Access Compliance Report

Public Rights-of-Way

| Intersection ID: 5365 | Main Street: MT_HOLLY-HUNTERSVILLE_RD | Cross Street: NEWFOUND_HOLLOW_DR | Location: NW |
| ADA ID: 138EF2300C15 | Ramp Type: Perp | Initial Pass/Fail: Fail | Overall Compliance: No |

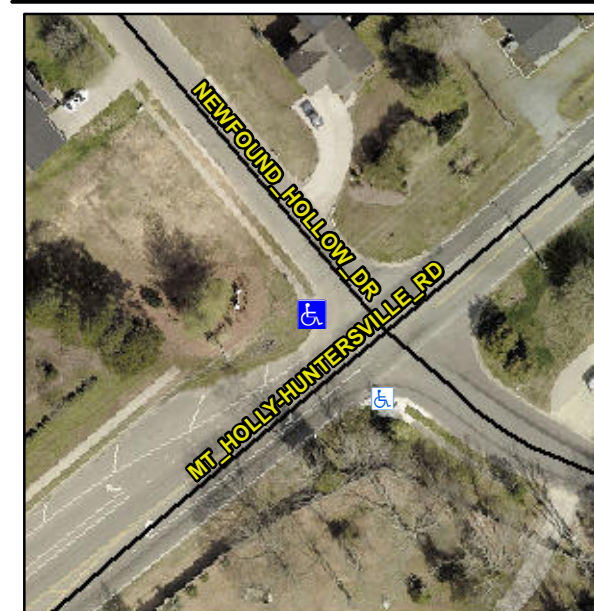
Not Found, R304.2.2

| Compliance | Description | Data | Compliance | Description | Data |
|------------|-----------------------|-------|------------|-----------------------------|------|
| N/A | Ramp Length (in) | 48.0 | No | Ramp Slope (%) | 8.4 |

Remove & Replace Entire Ramp.
